Access Compliance Report

Public Rights-of-Way

(Curb Ramps)

Intersection ID: 49922	Main Street: AUSTIN_DEKOTA_DR	Cross Street: LESLIE_DR	Location:	W
ADA ID: 50D5A79B5CA4	Ramp Type: BlendTrans1	Initial Pass/Fail: Fail	Overall Compliance: No	Severity Score: 10
Codes/Mitigation Info/Possible Solution		Field Measurements/Component Compliance

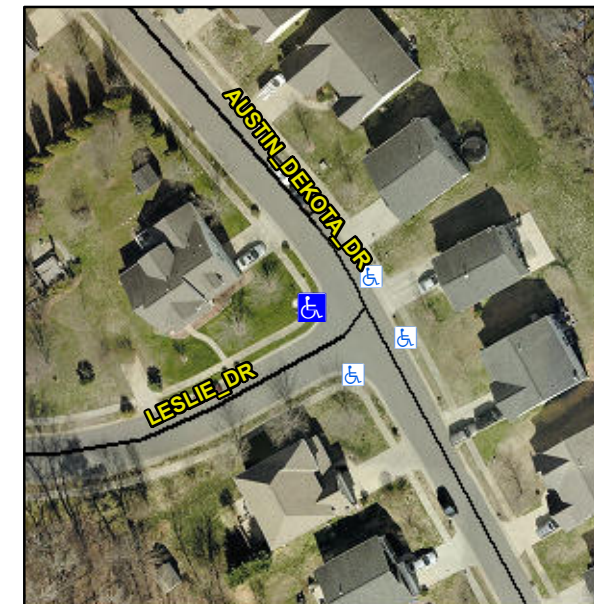
R304.5.1, R304.5.3

Compliance	Description	Data	Compliance	Description	Data
N/A	Ramp Length (in)	48.5	Yes	BlendTrans Slope (%)	2.0
No	Ramp Width (in)	47.5	No	BlendTrans XSlope (%)	4.5
N/A	Flare Type LT	N/A	N/A	Flare Type RT	N/A
N/A	Flare Slope LT (%)	N/A	N/A	Flare Slope RT (%)	N/A
N/A	Flare Traversable LT?	N/A	N/A	Flare Traversable RT?	N/A
N/A	Landing Length (in)	N/A	N/A	DWS Provided?	N/A
N/A	Landing Width (in)	N/A	N/A	DWS Contrast?	N/A
N/A	Landing Slope (%)	N/A	N/A	DWS Length (in)	N/A
N/A	Landing X Slope (%)	N/A	N/A	DWS Full Width?	N/A
N/A	Landing Curb? (Y/N)	N/A	N/A	DWS Offset (in)	N/A
N/A	Shared Landing?	N/A			
N/A	Gutter Ponding?	N/A	N/A	Gutter Slope (%)	N/A
N/A	Gutter Lip Ht (in)	N/A	N/A	Gutter X Slope (%)	N/A
N/A	Painted X Walk1?	No	N/A	Painted X Walk2?	No
	X Walk 1 Direction	To N		X Walk 2 Direction	To S
	X Walk 1 Width (in)	N/A		X Walk 2 Width (in)	N/A
	X Walk 1 Slope (%)	3.1		X Walk 2 Slope (%)	1.5
	X Walk 1 X Slope (%)	3.3		X Walk 2 X Slope (%)	4.4

N/A	Ramp inside XWalk1?	N/A	N/A	Ramp inside XWalk2?	N/A
	Road Slope (%)	4.3		Clear Space?	N/A
	Road X Slope (%)	2.0	N/A	Clear Space to XWalk (in)	N/A
N/A	Any Obstructions?	N/A	N/A	Storm Grate/Utility Hazard?	N/A
	Obstruction Type			Storm Grate/Utility Type	
		N/A			N/A
			Yes	Surface Condition? (G/P)	Good
			N/A	Curb Slope (%)	N/A

Remove & Replace Curb Ramp With Two New Directional Ramps or Equivalent.
